# MIAMI BEACH

### Staff Report & Recommendation

### Historic Preservation Board

SUBJECT: HPB19-0341, **1751, 1757 & 1775 Collins Avenue.**

*Raleigh Hotel, 2016 Photograph (rooftop additions highlighted in red proposed to be removed)*

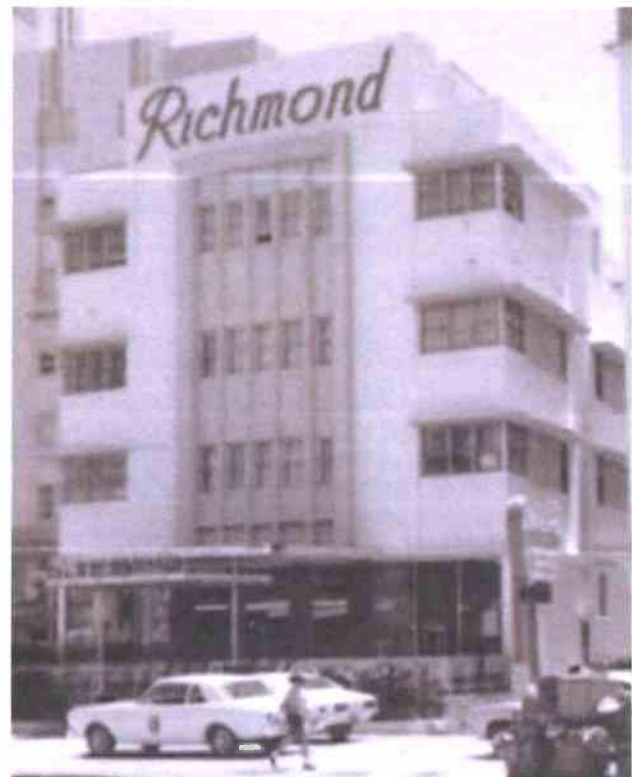
Additionally, as part of this submittal, an expanded scope of restoration is proposed including the removal of several inappropriate rooftop additions (see image below). These rooftop additions have an exceedingly adverse impact on the integrity of the original 1940 Dixon design and their removal will restore the skyline of the Raleigh Hotel to its former grandeur. Other notable restoration includes the reintroduction of a missing window within each set of ribbon windows along the broad curved corner of the building.

Staff is extremely supportive and enthusiastic of the expanded scope of restorative work. This additional scope in conjunction with the previously approved restoration will reposition the Raleigh Hotel as one of the most meticulously restored Streamline style hotels in the world.

- i. Consistent with the proposed plans, the following rooftop additions shall be removed: the 2-story penthouse, the 1-story enclosure at the southwest corner of the building, the 1-story enclosure at the north west corner of the building and a portion of the rooftop addition at the 8<sup>th</sup> level, in front of the north side of the tower element.
